06 November 2020

Our ref: 202007_003

RE: SSD-10371 Trinity Grammar School redevelopment – Response to Submissions – Transport and Access comments

Figure 2 - Base model diagram of Prospect Road/Old Canterbury Road intersection

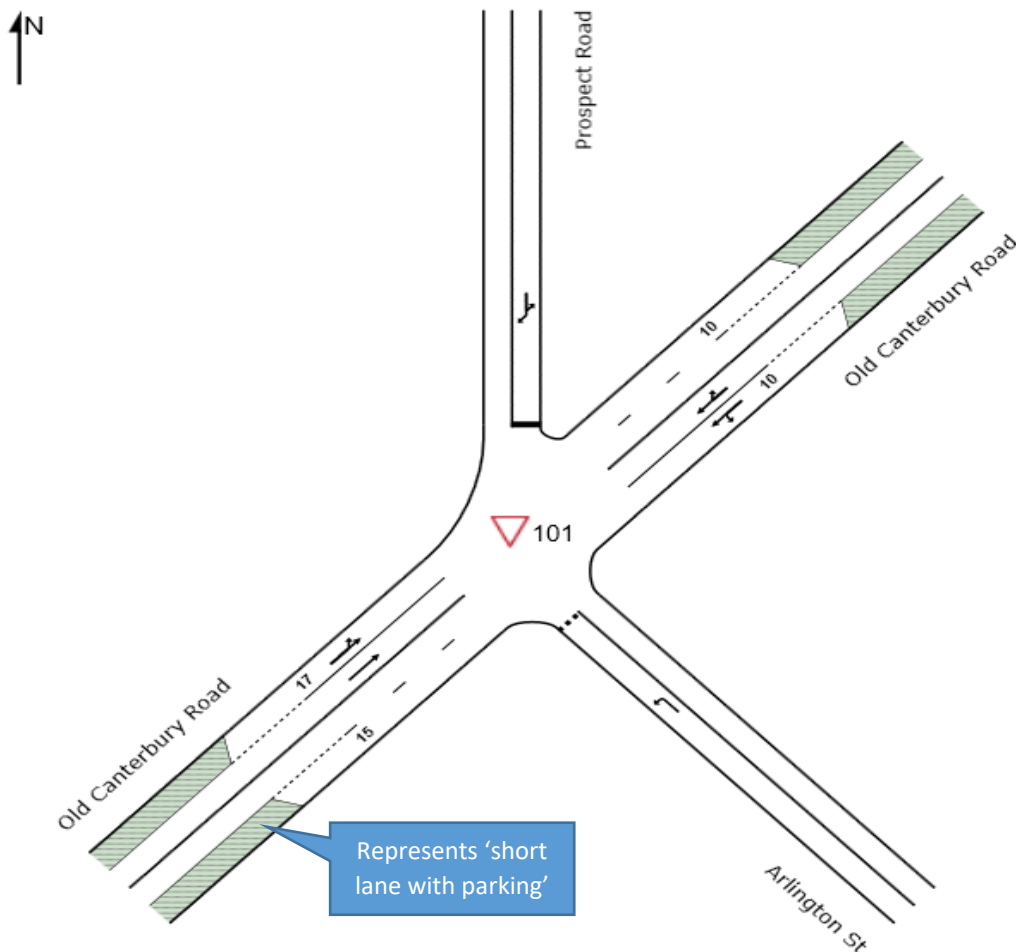
Notwithstanding, the above conclusion regarding the LoS, the SIDRA analysis and associated tables of results should identify additional delays or queue lengths due to the additional design traffic volume (which is anticipated). The TA report should then address the impacts of the additional queue lengths and delays (if any) and propose suitable mitigation and management measures to minimise the impacts on the surrounding traffic network.”

The intersection of Prospect Road/Old Canterbury Road experiences the most impact due to the development. The most affected movement at this intersection is on Prospect Road and those attempting to turn right onto Old Canterbury Road. This movement's delays are expected to increase by up to 15% in the AM, 30% in the PM, and the queue increases by up to nine (9) vehicles in both peak periods. The impact is significant enough to warrant mitigation.

In the base traffic model a “short lane with parking” has been included along both kerbside lanes on the Old Canterbury Road approaches, and only increasing to two lanes for a distance of 10m either side of the intersection (due to standard road rules and regulations).

This subsequently reduces the flow of vehicles through the intersection to a single lane and therefore increases the delay to Prospect Rd further (as gaps in traffic are less frequent and the flow of vehicles is more constant when only a single lane is operational).

It is noted that the intersection is already identified to be at capacity in the peak periods without the development, and therefore the mitigation proposed is identified to mitigate the

new development only and not resolve the base issue that is not directly attributed to the development.

Figure 4 - Proposed mitigation 2 - preliminary design

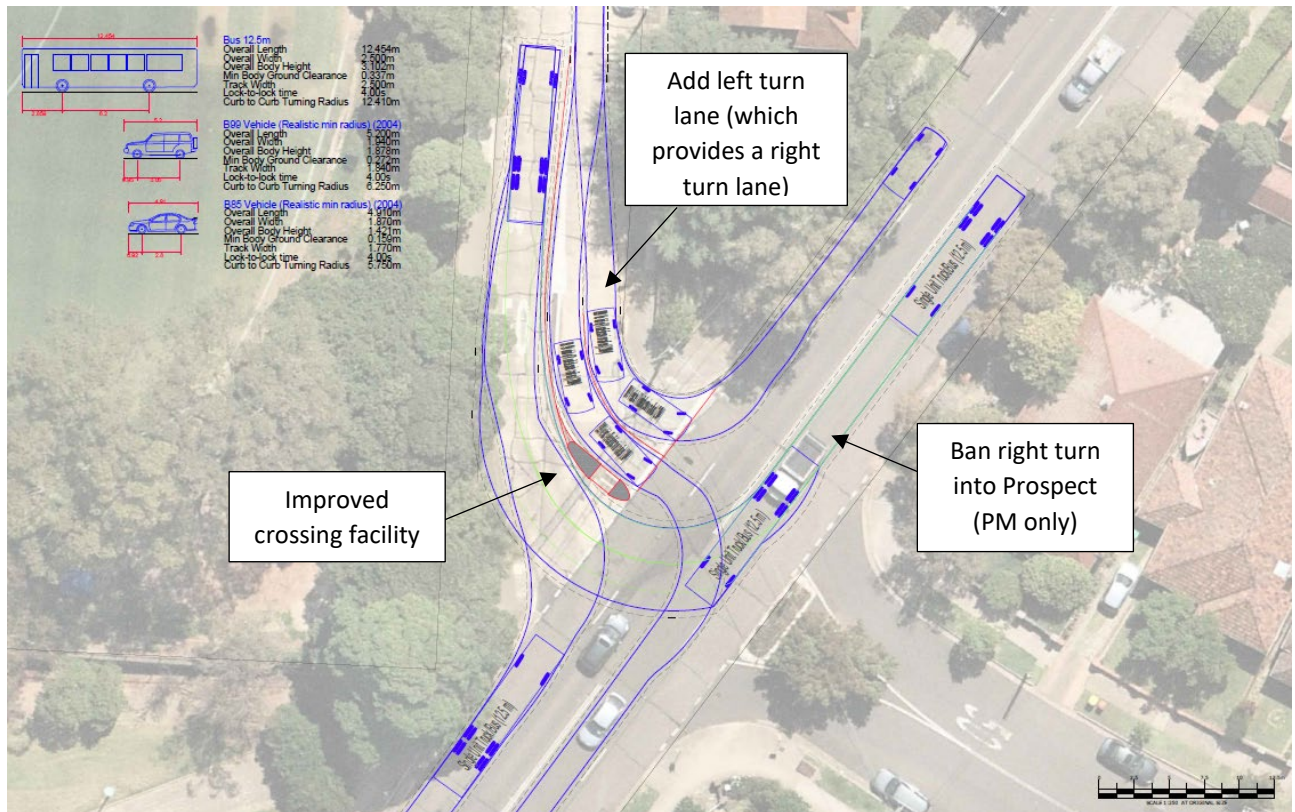
“Consider widening of the island at the intersection of Old Canterbury Road and Prospect Road to provide a refuge island to improve safety of pedestrians at the intersection.”

The Mitigation 2 (step two) model builds on Mitigation 1 and introduces a short, left turn lane out of Prospect Road and bans the right turn from into Prospect Road in the PM only.

The right turn ban in the PM is acceptable as data shows there are only 12 vehicles making this turn currently. People wanting to make this movement can instead turn through the Old Canterbury Road / Hurlstone Avenue intersection.

This mitigation returns the PM model to a comparable position as the base model in that all movements are improved in regard to delays and queues – the exception being a 0.9s delay increase on Arlington Street and the Degree of Saturation (DoS) increases by 2.4%. The AM peak further improves due to the added left turn lane.

The design retains the inbound (to Prospect Road) movements as per existing but also enables a widening of the median crossing island to 1.2m producing an improved pedestrian outcome from the existing condition.

The design still allows for buses to maintain their existing turning movements (i.e. Route 406 right turn from Prospect Road into Old Canterbury Road, and various bus routes left into Prospect from Old Canterbury Road), so public transport services are not impacted. For the swept paths, the modelled vehicle inbound is a 12.5m rigid bus.

Based on this preliminary drawing, this proposal can be carried out within the existing kerb alignment which reduces the need for and impact of any lengthy civil works.

As per our response regarding the proposed traffic mitigation measures (Item 4 for DPIE), there is an opportunity to realign and widen the existing median on Prospect Road at the intersection of Old Canterbury Road.

The preliminary design demonstrates that widening the median to 1.2 metres is feasible, and final dimensions would be subject to further design development.

Figure 6 - Location of Bicycle Facilities as shown in the EIS

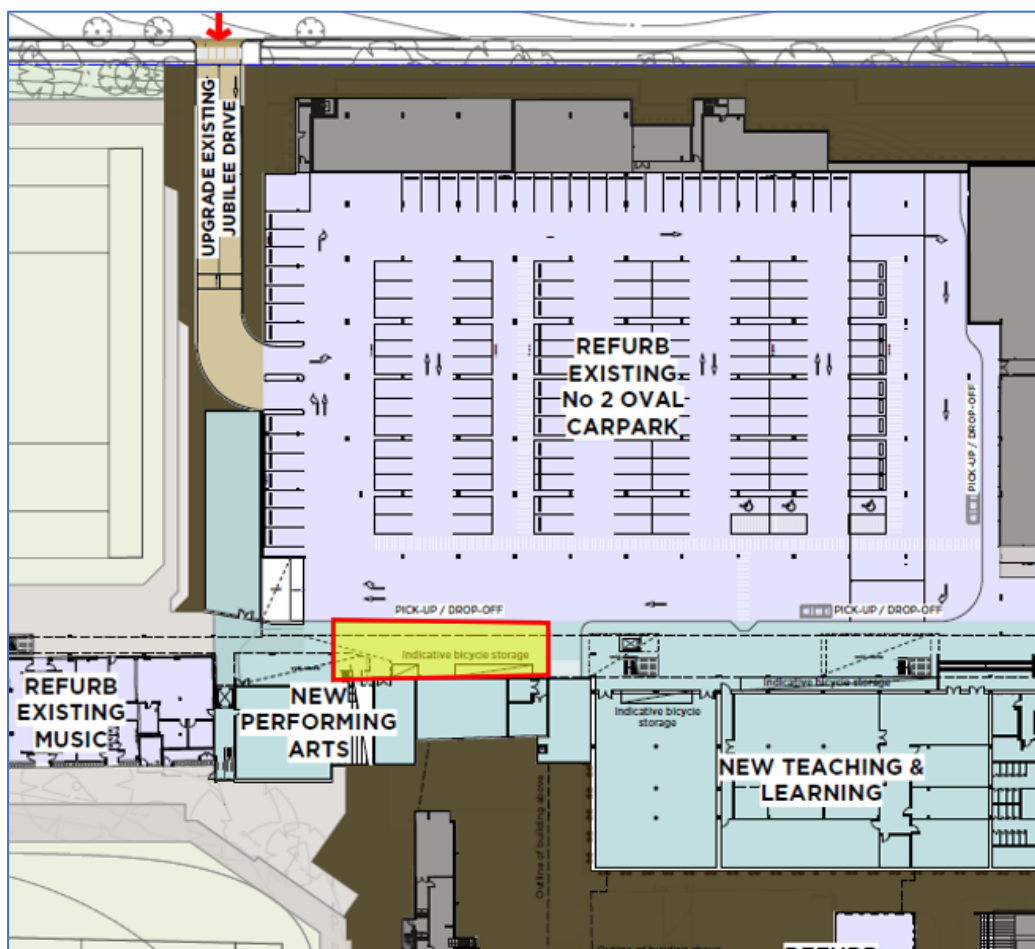
“It is unclear whether bicycle parking spaces with end of trip facilities are provided on site. Adequate bicycle spaces with end-of-trip facilities should be proposed and identified in the architectural plans.”

In the Environmental Impact Statement (EIS), the Bicycle Parking Facility was identified on Drawing No. DA111 in the basement car park. Please see the reference below. Access to showers and lockers for an end of trip facility are in the existing aquatic complex.

However, on further assessment, this location for the bike parking is not ideal given that bike riders will need to mix with the car park traffic to access the bike parking. The alternate is to enter the school at ground level, dismount, and walk the bike to the bike parking. These actions are likely to be a disincentive to bike riding.

Figure 8 - Proposed construction vehicle routes

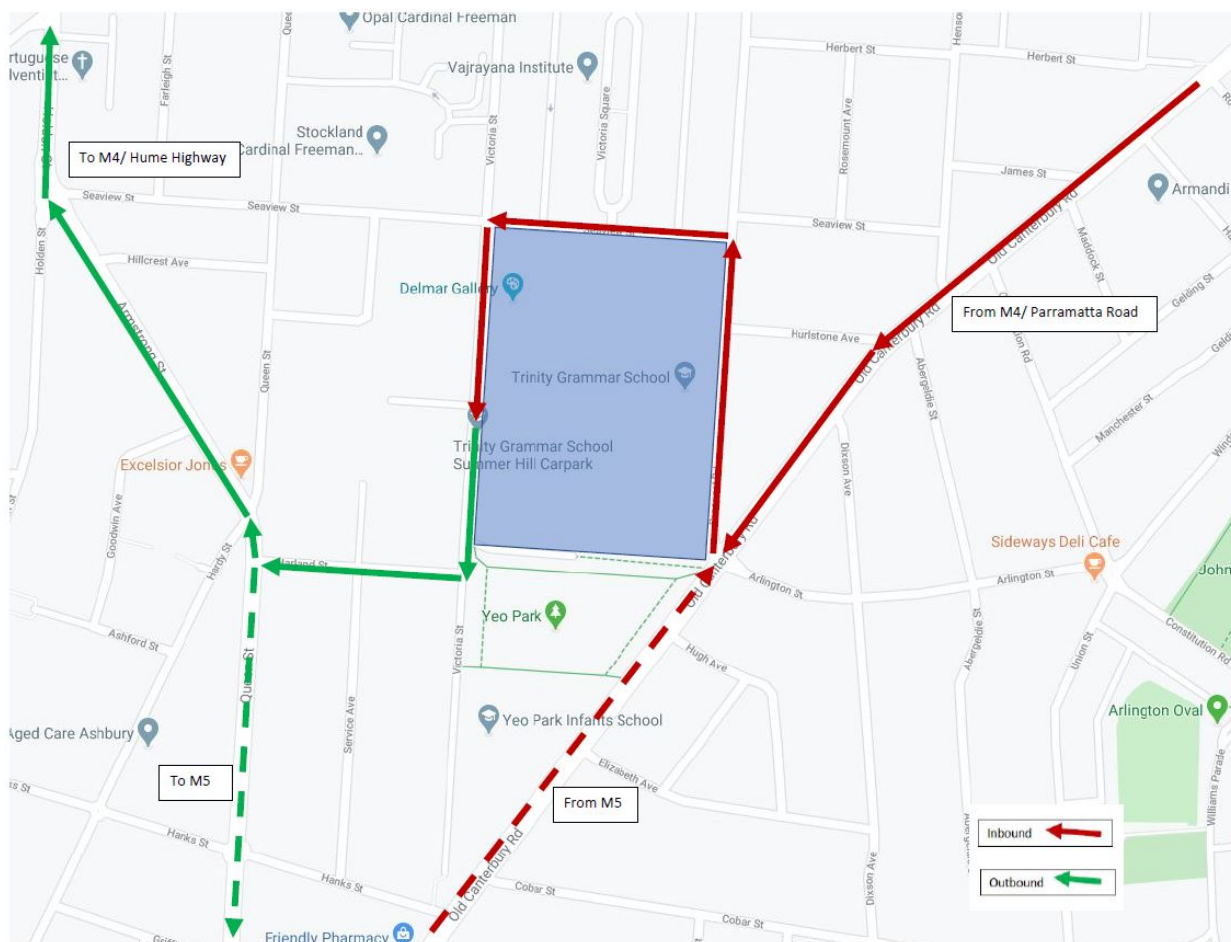
“Details of construction traffic arrival and departure routes should be included in the TA report. The details of truck turning movements (considering the various sizes and the width of the access roads) and any associated issues / pedestrian safety matters in relation to the construction traffic routes must also be identified, noting that the site is located in a residential area.”

These truck types are generally Medium Rigid Vehicles and with the generous width of Victoria St, the turning movement for these vehicle types to and from site is comfortable. Swept paths to/from the proposed gates will be carried out as part of the Construction Traffic Management Plan (CTMP) development.

Regarding truck routes, it is proposed that heavy vehicles enter and exit the site via the preliminary routes outlined below. These routes are intended to reduce the heavy vehicle traffic on the local street network, to reduce the load of heavy vehicles on any particular street, and to give the shortest possible route for heavy vehicles to the state road and motorway network. Vehicles will turn left in and left out at the site gates on Victoria Street.

See below for proposed construction vehicle routes. These routes are to be confirmed or amended as part of the CTMP development once further detail is developed.

Figure 10 - Trinity school bus service routes (AM services)

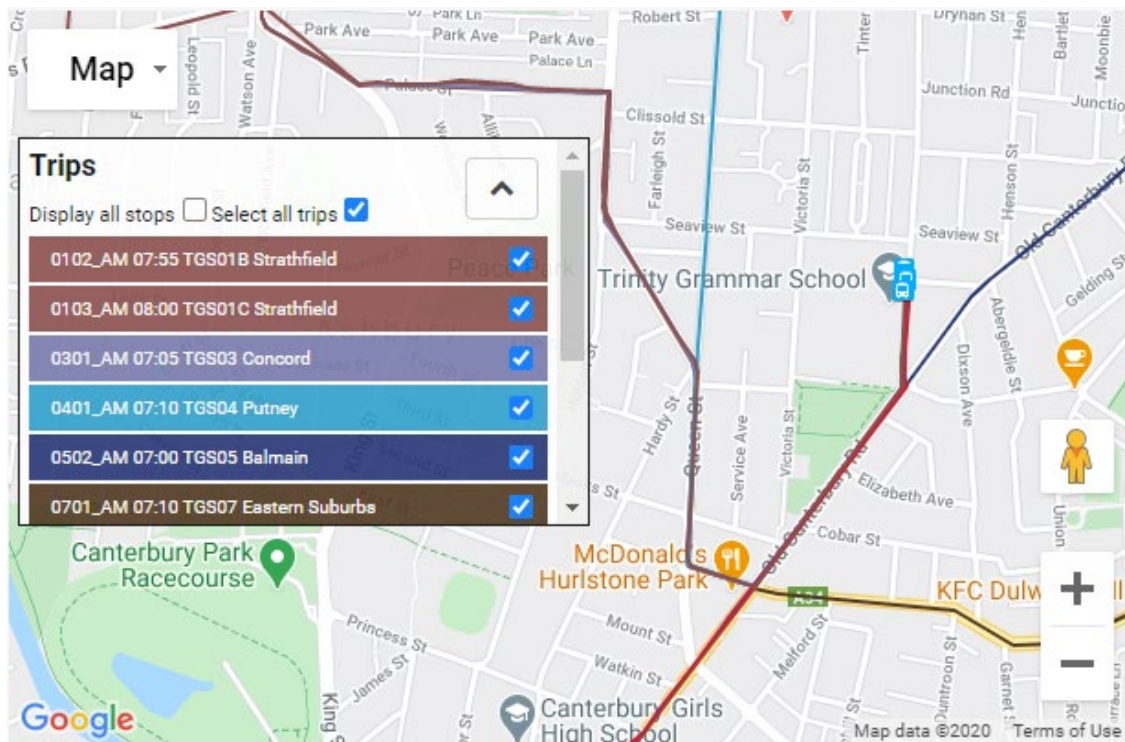
“Details on bus drop-off areas / coach parking as well as number of buses and frequency are to be provided in the TA report.”

The Trinity school buses predominantly drop-off and pick-up from the western kerb of Prospect Road at the bus stop near the main gates and Chapel Drive. In the morning, Trinity buses enter from Old Canterbury Road and turn left into Prospect Road and do not contribute to the queuing at Prospect Road.

With a total length at Prospect Road of 65 metres on the western side, this is ample capacity to capture the maximum buses (at 12.5m each) that arrive or depart to service the school. We note that the six buses that depart after 4pm are spread across a 1.5-hour timeframe which can be serviced by the bus stops.

Appendix 3 – Victoria Street service driveway swept paths

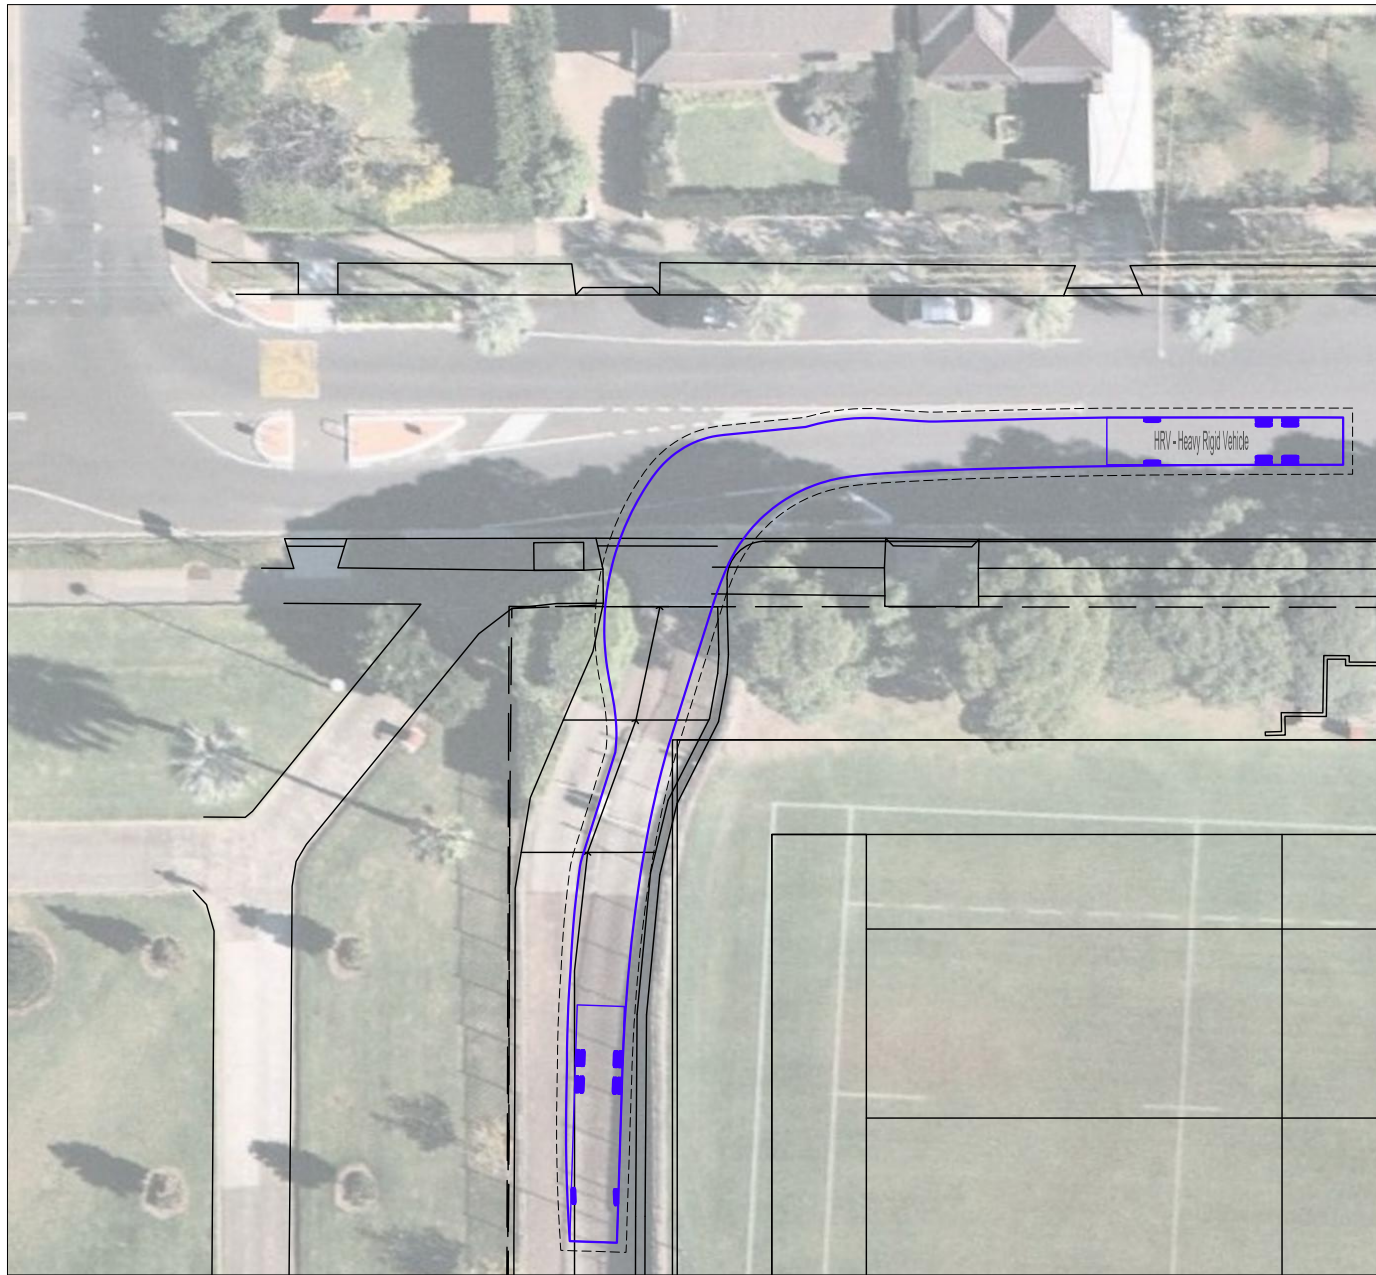
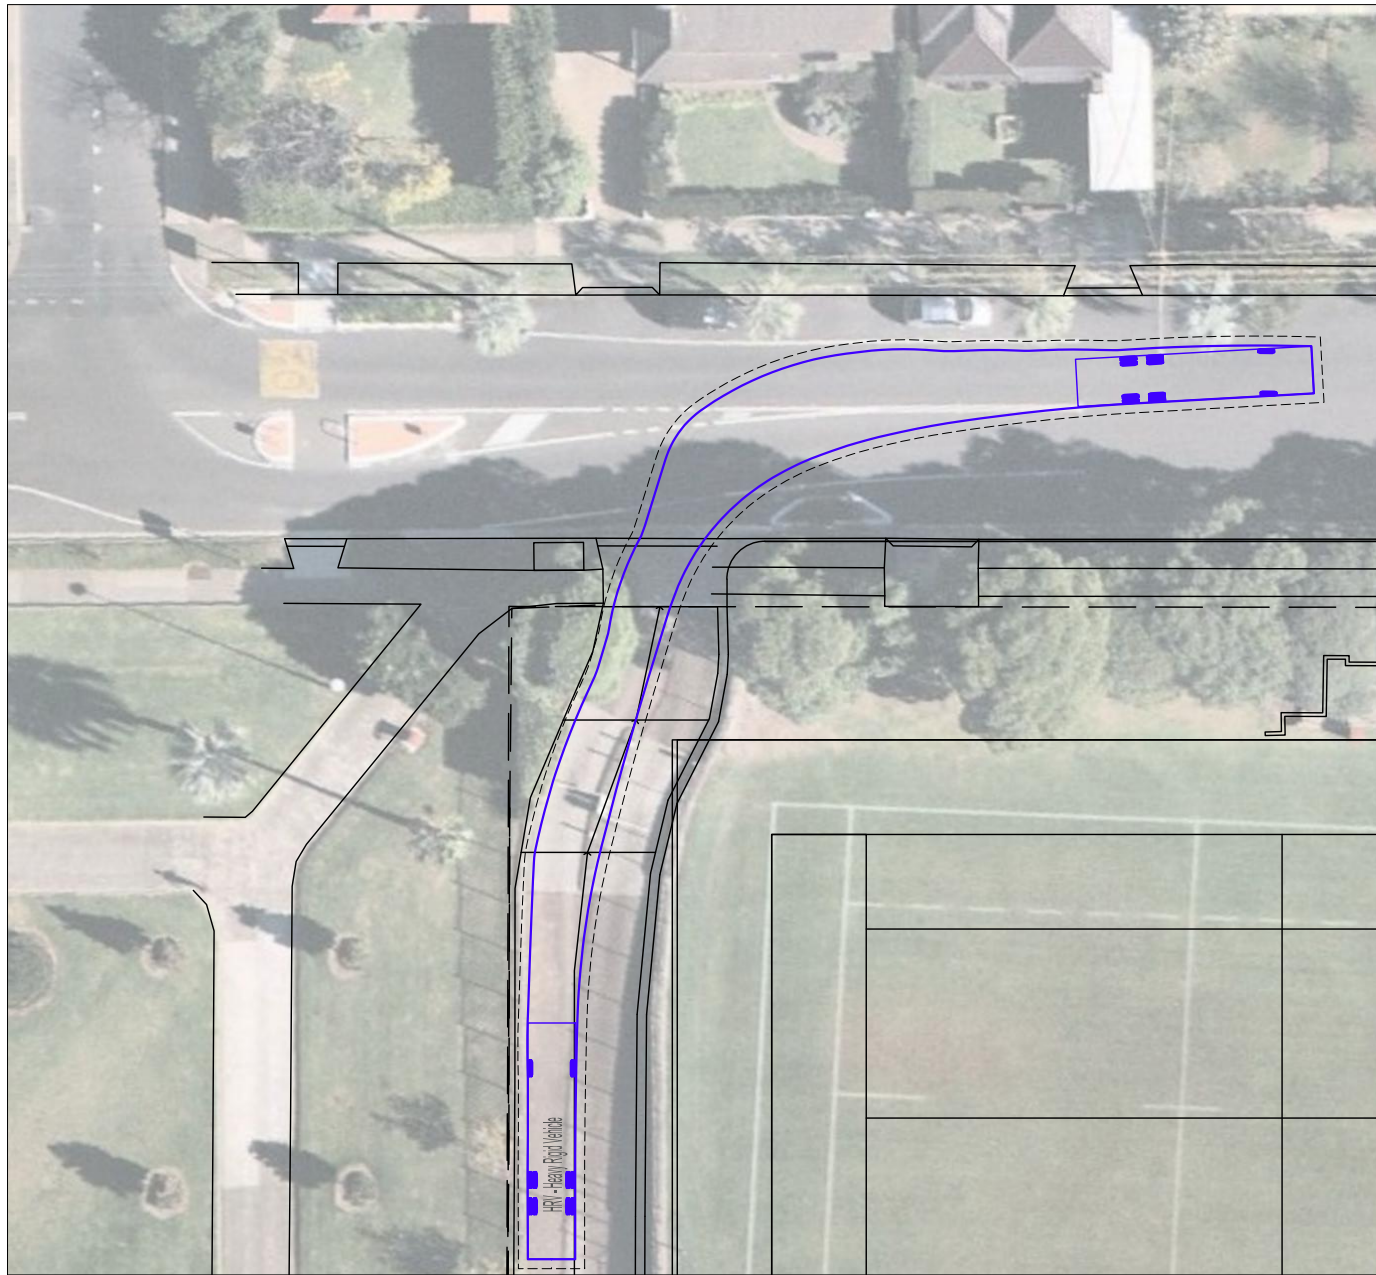
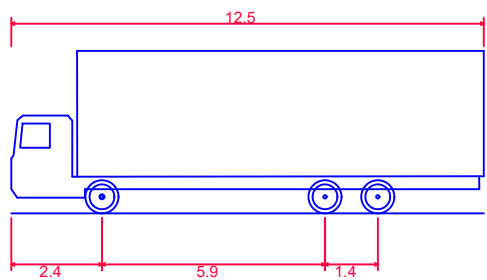
“The other measure proposed at the southern driveway is to remove the adjacent traffic island to allow delivery vehicles to turn left out of Harland Street into Victoria Street and then a quick right into the southern driveway. The traffic island proposed to be removed is in fact a pedestrian refuge and its removal is not supported. The removal of this refuge will severely impact pedestrian safety as it is adjacent to the main southern driveway whose use is being intensified and which has poor sight lines for and of pedestrians and vehicles due to the existence of an electrical substation adjacent to the driveway. Delivery vehicles should only access the driveway by turning left in.”

The movements to and from the driveway for service vehicles were reviewed to determine the potential for access without any impact on the pedestrian refuge. While the original intent for access to/from this driveway was to limit heavy vehicle movements along Victoria Street, it was not possible to achieve turning movements for Medium Rigid Vehicles (MRV) or Heavy Rigid Vehicles (HRV) to/from Harland St without adjusting or relocating the pedestrian refuge.

To resolve this concern, we have tested vehicle movements in and out via Victoria St (north) and all movements can be achieved. Therefore, the proposed entry and exit from this driveway for heavy vehicles is to be left in and right out at Victoria Street only.

See **Appendix 3** for the swept path drawings.
